N2832A-02

# Modification Recommended Service Note

N2832A 13 GHz InfiniiMax III+ Series Probe Amplifier  
Serial Numbers: ALL

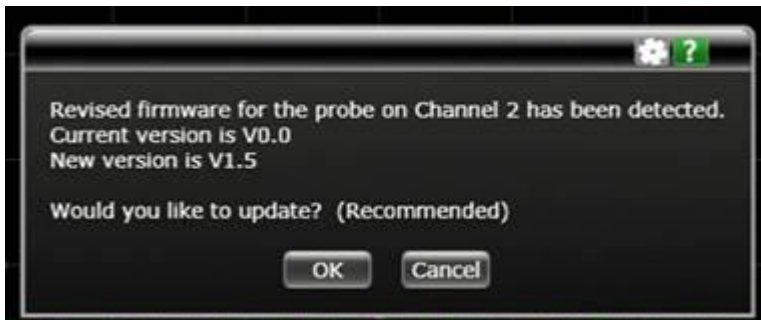
1. Ask the customer if he/she has seen the following message when plugging his/her probe onto an oscilloscope:

2. Regardless of the customer's answer to the question, plug the customer's probe onto a Service Center scope with software version 06.20.00701 or later.
3. If the Customer said No in step 1 or was unsure: tell the customer that Keysight recommends downloading latest scope software version—Version 06.20.00701 or later. Continue with standard procedure.
4. If the Customer said Yes, the probe appears to function normally on the scope, and it passes calibration, the probe has been fixed. Send the original probe back to the customer, and tell the customer that Keysight recommends an upgrade to oscilloscope software—Version 06.20.00701 or later to prevent this issue from re-occurring to their probe.
